## **CORPORATION OF THE CITY OF VERNON**

### **ADVISORY PLANNING COMMITTEE**

**TUESDAY, AUGUST 17, 2021 AT 4:00 P.M.**

## **A G E N D A**

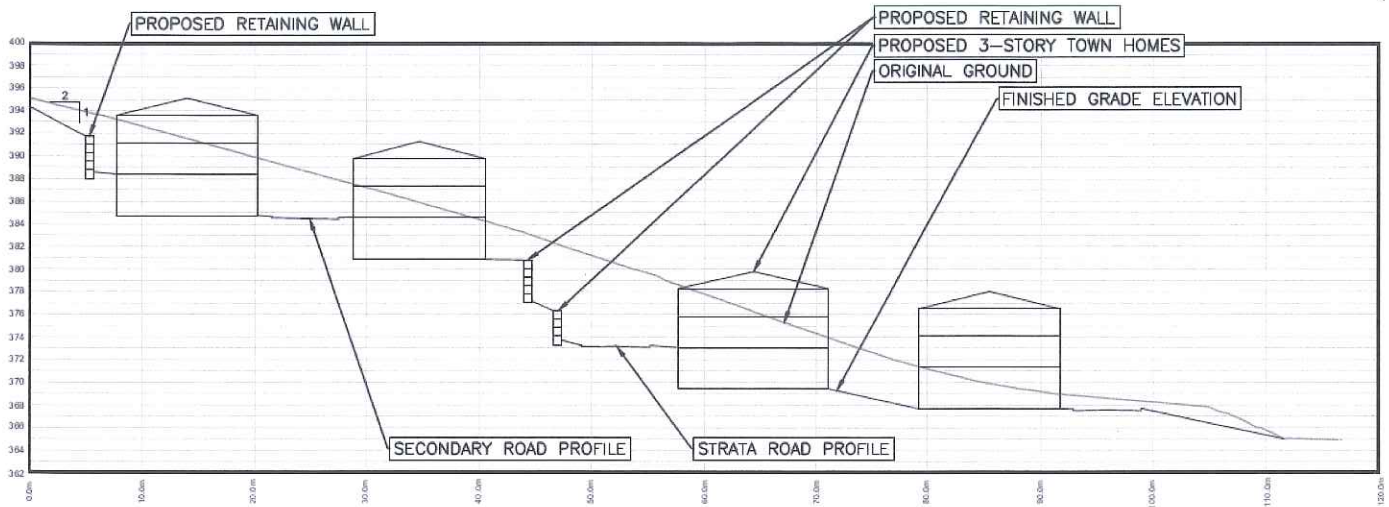
Furthermore, Figure 7 of the *Hillside Guidelines* clearly illustrates the City's preferred options for hillside development, as well as an illustration of the type of grading that is not desired:

CROSS-SECTION DETAIL #3  
SCALE 1:500

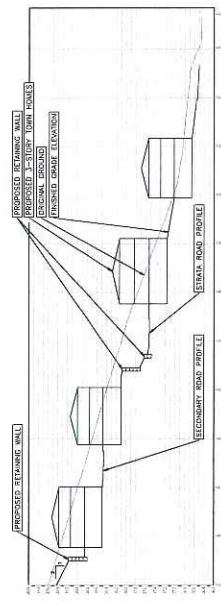
Cross-Section Detail – 3 in Overall Site Grading Plan Cross-Sections - (GR-2) Drawing No. 55-2 of the application shows that the development as proposed is not in accordance with the City's preferred options:

- a) Request to vary the 30% maximum slope vegetation and the proposed height from 2.5 storeys to 3 storeys to accommodate visitor parking:
  - i. The site plan and cross-sections of the proposed development show a significant amount of site grading (both cut and fill) which is not supported by the City's Hillside Design Guidelines. Further removal of soils on the site is not supported by Administration.
